SERVICE BULLETIN
NO:99010-r1

MODELS : TX-DS575

SUBJECT : Noise is heard from "VOLUME MIN" to "VOLUME 1".

SUBJECT : Change of parts

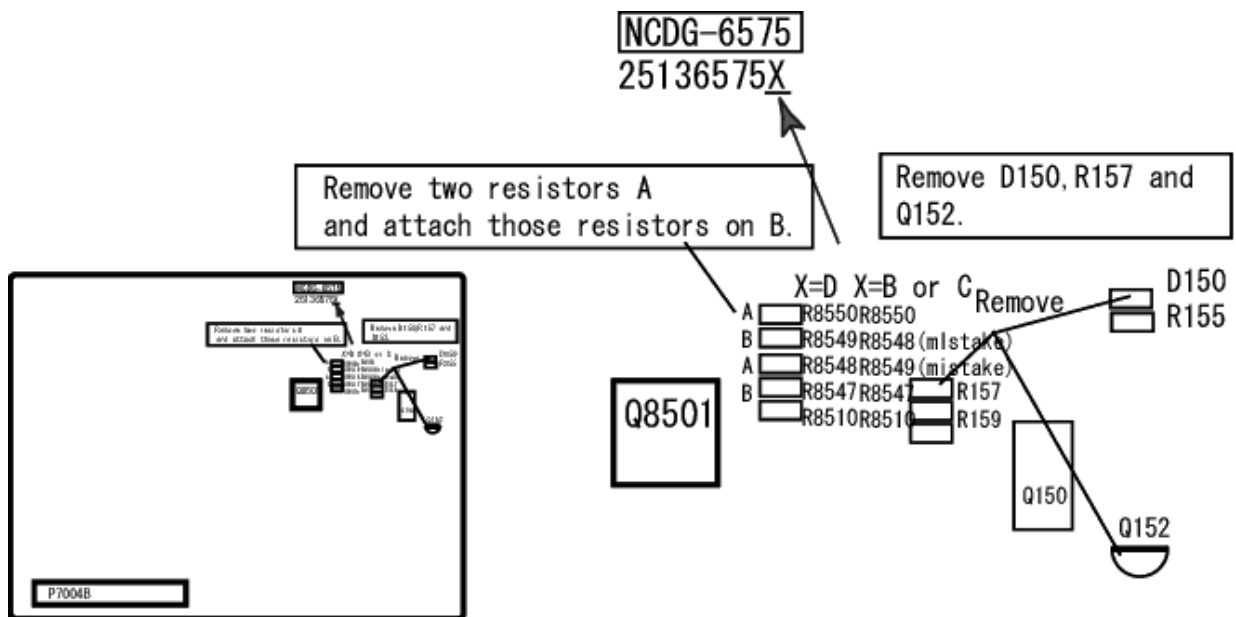
This model is used the microprocessor of 3 types.

When replace the microprocessor Q7001, refer to the remarks below.

Note: When you change the microprocessor from 045-3BA to 047-3BA, remove 2nd PLL circuit and change the setting of A/D,D/A Converter IC Q8501.

Item	Description	Part No.	Contain of change	Remarks	Application
1	MPD780208GF-045-3BA	22241343		Use item 2 instead of 1. Refer to note below.	MD:1-10600 13001-14600 MP:5001-6900
2	MPD780208GF-047-3BA	22241398	Elimination of 2nd PLL circuit	Use same IC.	MD:10601-13000 14601- MP:1-5000 6901-
3	MPD780208GF-056-3BA	22241419	Improvement of noise when DOLBY.	Use same IC.	From Oct. 1999

AM Radio interference

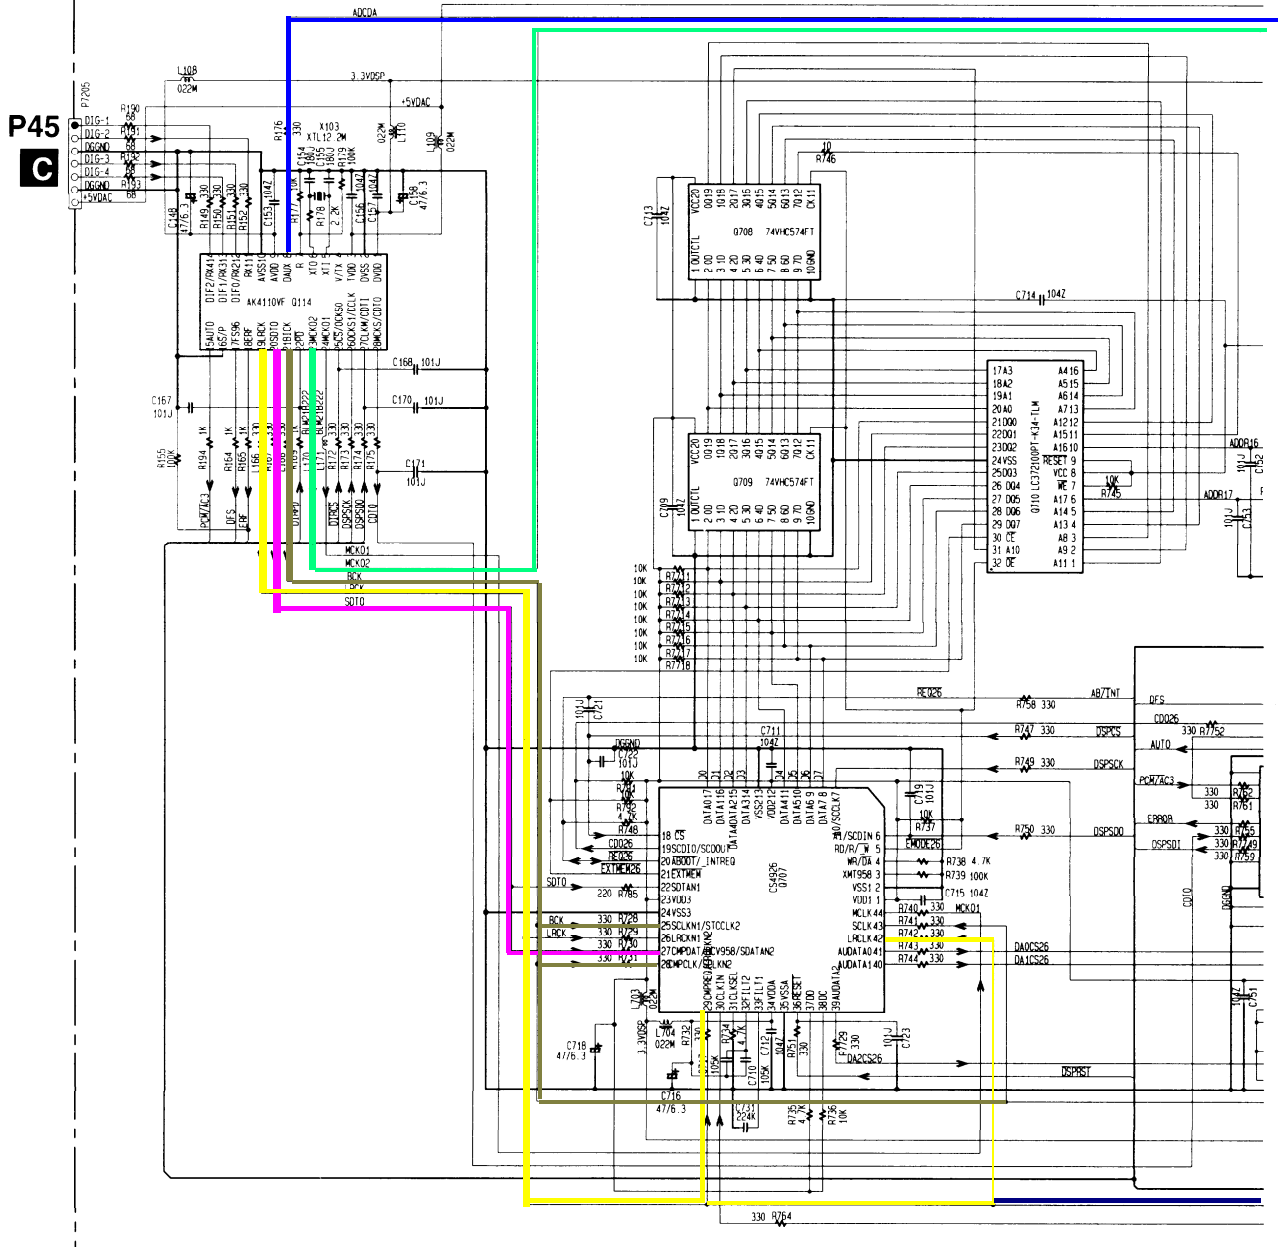
In some cases, an AM radio transmitting near by the consumer house (3miles or less of radius est.) may cause audio of the modulated AM signal be heard through center and rear channels regardless of input setting. AM broadcast Frequency range 1360Khz ~1510Khz.

On Volume PCB NCVD-6746, add D204 with 1SS133 Part Number #223163. In place of C3686 place a jumper. Resolder any loose RCA plugs and ground connectors.

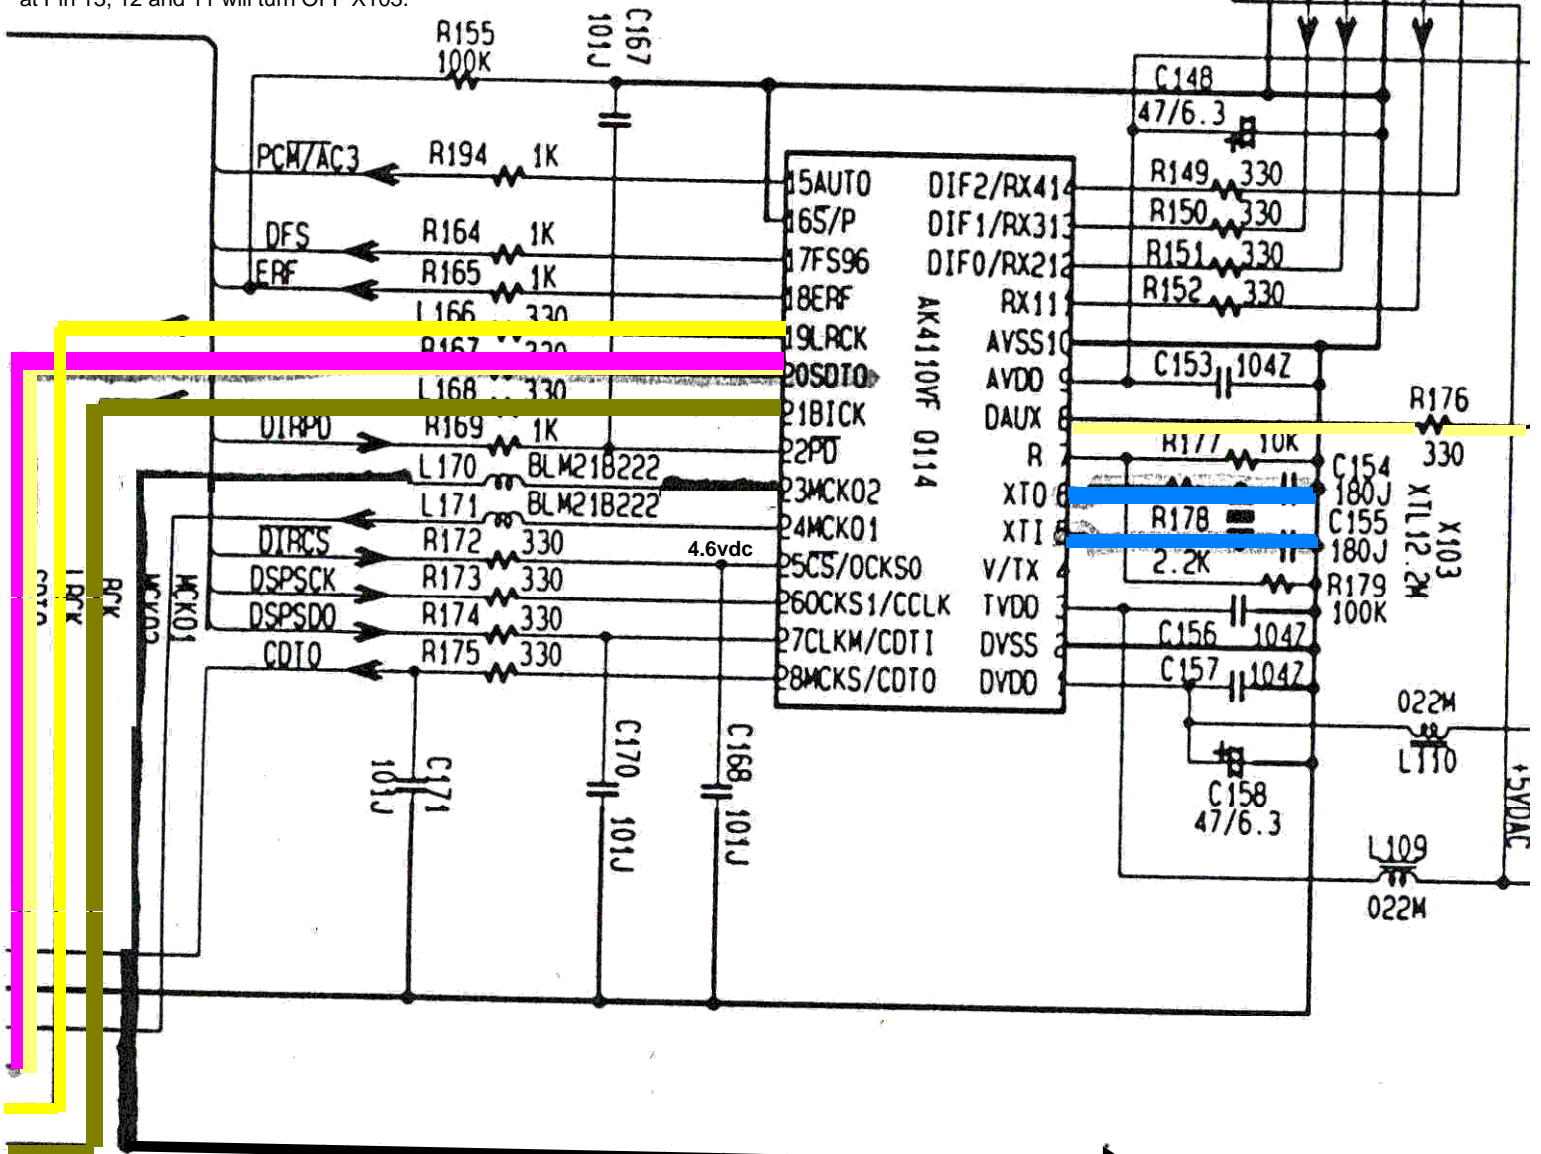
Audio Data from Q8501 Pin 9 arrives at Pin 8 of Q114.

Same data will find its way out at pin 20 of Q114.

It is important X0-XI Pin 5, and Pin 6 work correct and that 12.2Mhz oscillation is present. No noticable drift or Jitter should be noticed.

It is conditional that audio data is present at Pin 8 (DAUX) of Q114 and that X-tal X103 is ON in-order for Q114 to operate properly. The digital condition set forth at Pin 15 and 17 along a presence of digital data at Pin 13, 12 and 11 will turn OFF X103.

Q707 (problem begins to show at:)

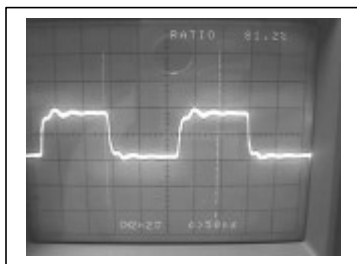
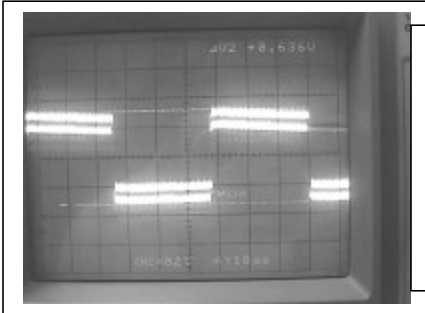
Pin 39 and 41 has no data.

Pin 30 appears this way.

Pin 41 has a problem as seen. This point is normally 4.5vpp rather than .636vpp. The data appears to be corrupted or very low. If the unit is working properly this point becomes very high and clear data is present. At the same time when the unit appears to work, Q707 temperature runs warmer than when it is not.

At this point a re-check of pin 8 through 17 revealed that some of the data line DC voltages were not as they should be. See chart.

Q710 Defective. Replaced and unit worked.
